Docket No. 50-244

Change No. 9
License No. DPR-18

CHANGE NO. 9 TO THE TECHNICAL SPECIFICATIONS

R. E. GINNA NUCLEAR POWER PLANT UNIT NO. 1

Figure 2.1-1. Core DNB Safety Limits. Two Loop Operation, 100% Flow Ginna Cycle 3.

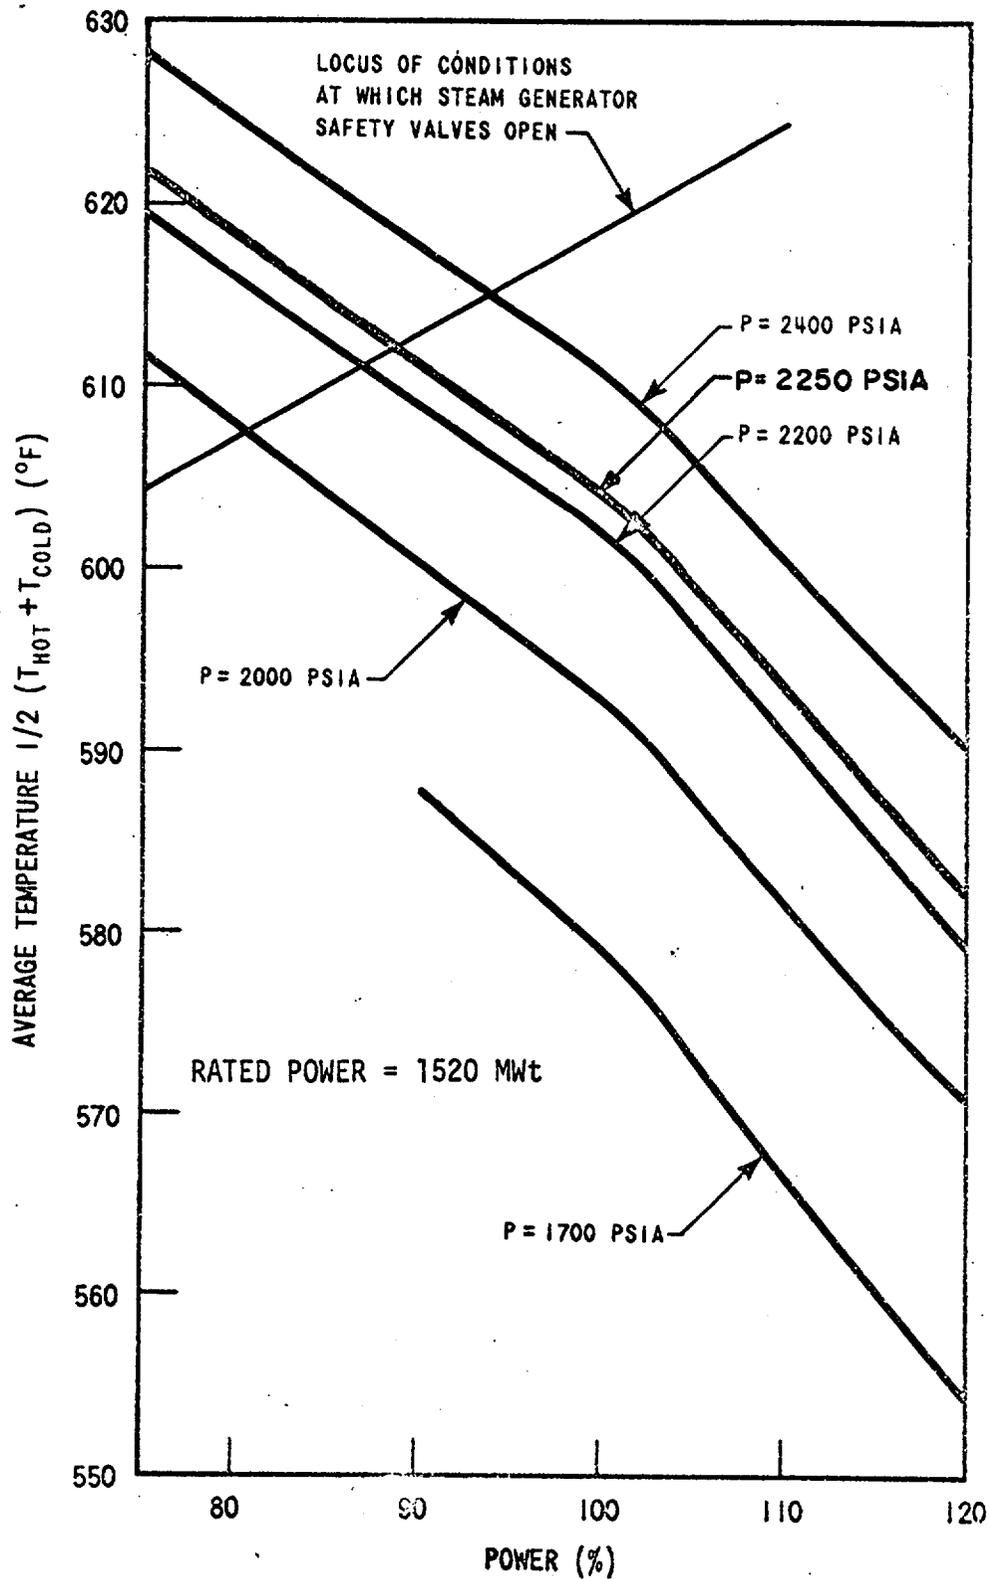
"Additional peaking factors to account for local peaking due to fuel rod axial gaps and reduction in fuel pellet stack length, as well as a penalty to account for rod bowing, have been included in the calculation of the curves shown in Figure 2.1-1.

"Since it is possible to have somewhat greater enthalpy rise hot channel factors at part power than at full power due to the deeper control bank insertion which is permitted at part power, a conservative allowance has been made in obtaining the curves in Figure 2.1-1 for an increase in $F_{\Delta H}^N$ with decreasing power levels."

Replace Figure 2.1-1 with the attached revised figure.

Figure 3.1-4 Maximum Steam Generator Leak Rate versus Time

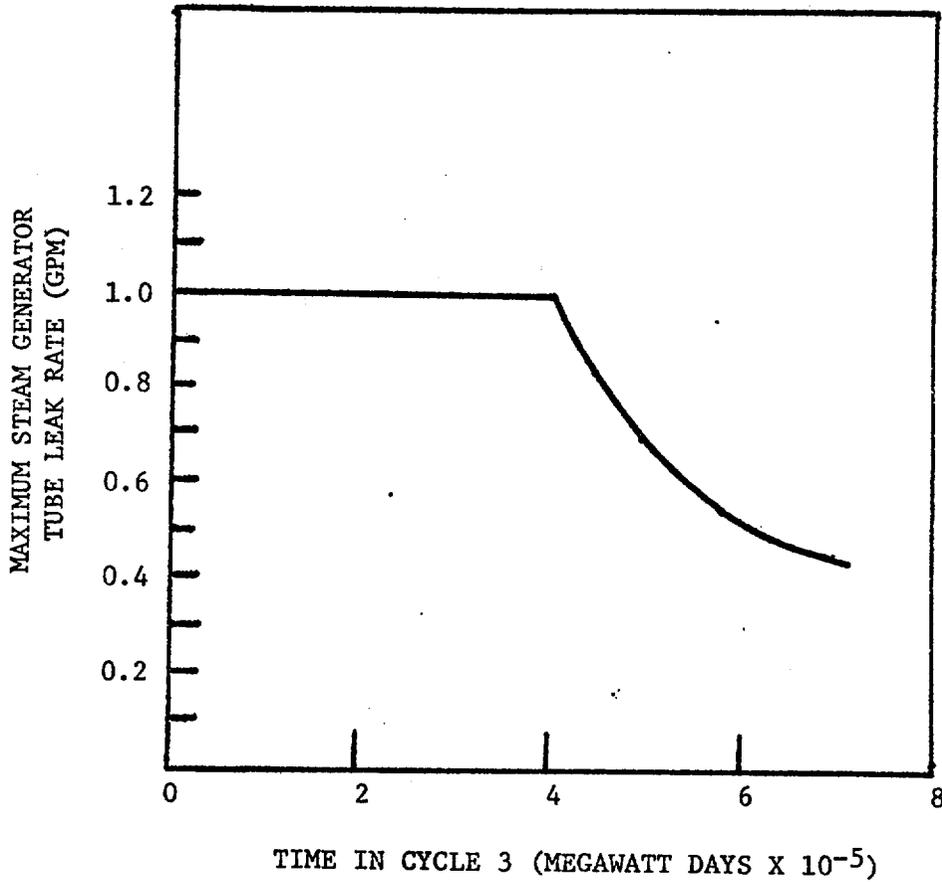
"3.1.5.2 Steam generator tube leakage in any one steam generator shall not exceed the limit derived from Figure 3.1-4 when averaged over a period of 24 hours. If this limit is exceeded, the reactor shall be shut down within 8 hours."

Add the attached new Figure 3.1-4 entitled "Maximum Steam Generator Leak Rate versus Time."

Figure 3.10-1. Control Bank Insertion Limits
Ginna Cycle 3

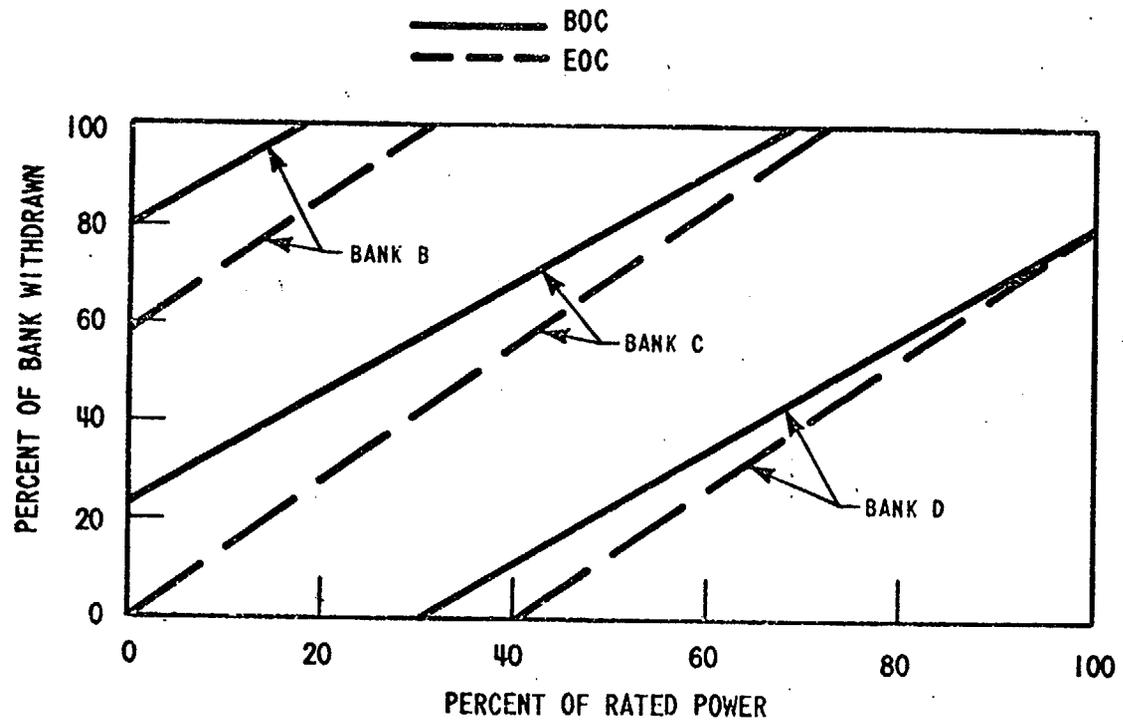
"After the boron concentration has been reduced to 600 ppm, the limits may be adjusted to the end of core life values as shown by the dotted lines in Figure 3.10.1. Furthermore, the control rod banks are moved sequentially with a 100 (+5)-step overlap between successive banks."

Replace Figure 3.10-1, "Control Rod Insertion Limits" with the attached revised Figure 3.10-1.

Figure 3.10-3. Power Spike Factor versus Elevation

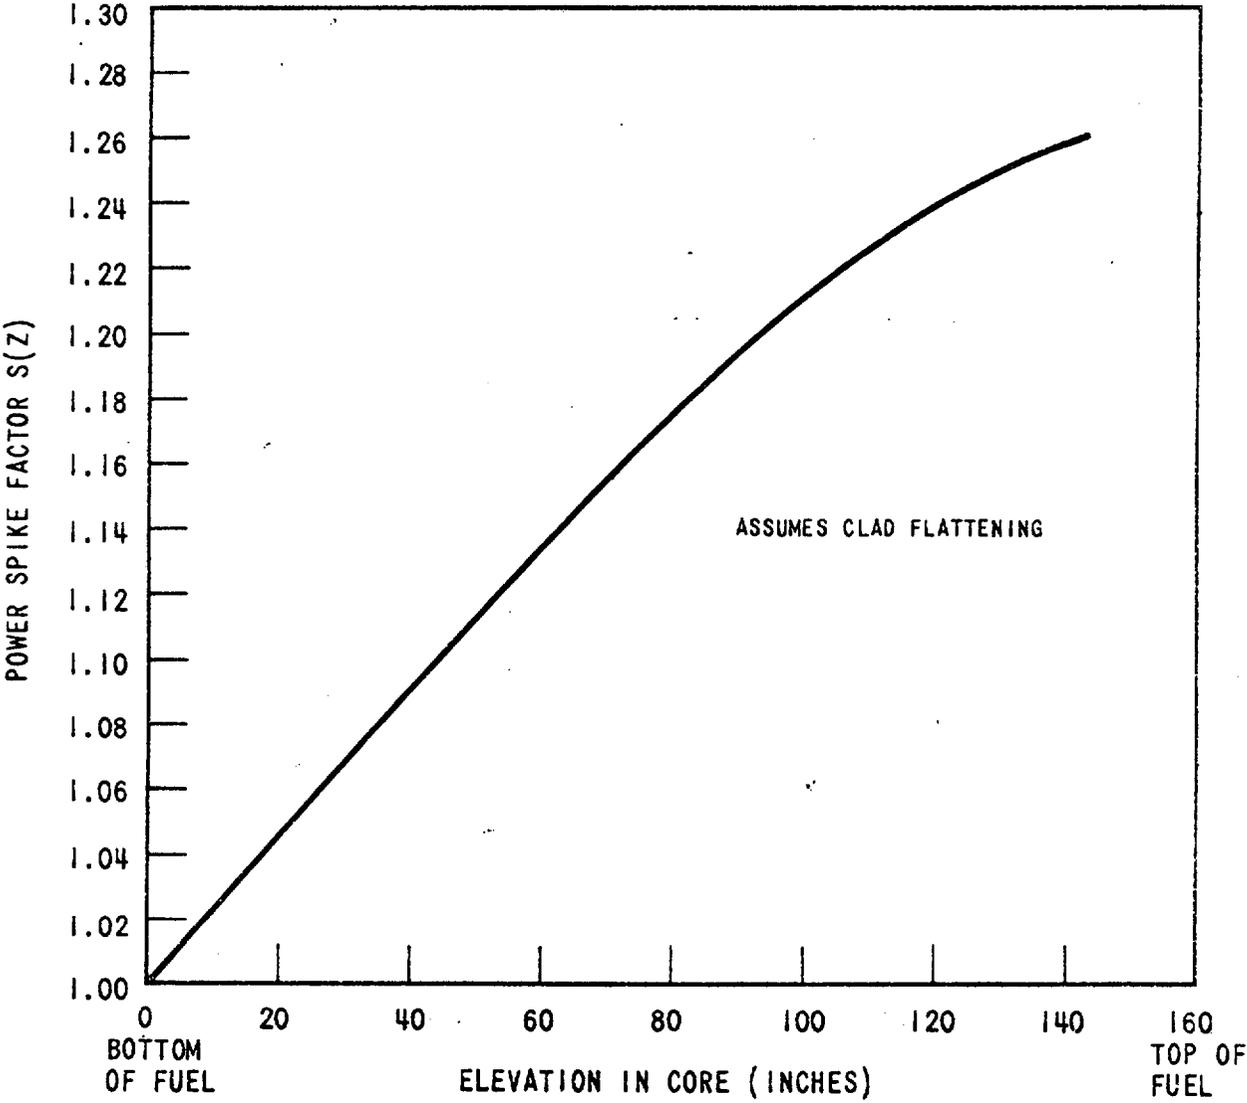
To obtain F_Q^N from the measurement, the measured value of F_Q^N shall be multiplied by the peaking penalty as shown in Figure 3.10-3 (at the appropriate core location) to account for fuel densification and potential clad flattening. If the measured F_Q^N and F_{Δ}^N exceed the limiting values with due allowance for measurement error, the maximum allowable reactor power level and the Nuclear Overpower Trip set point shall be reduced by one percent for each percent which F_{Δ}^N or F_Q^N (for the core or Region 4A) exceed the limiting values, whichever is most restrictive. If the hot channel factors cannot be reduced below the limiting values within one day, the Overpower ΔT trip set point and the Overtemperature ΔT trip set point shall be similarly reduced."

Insert new Figure 3.10-3, "Power Spike Factor versus Elevation."
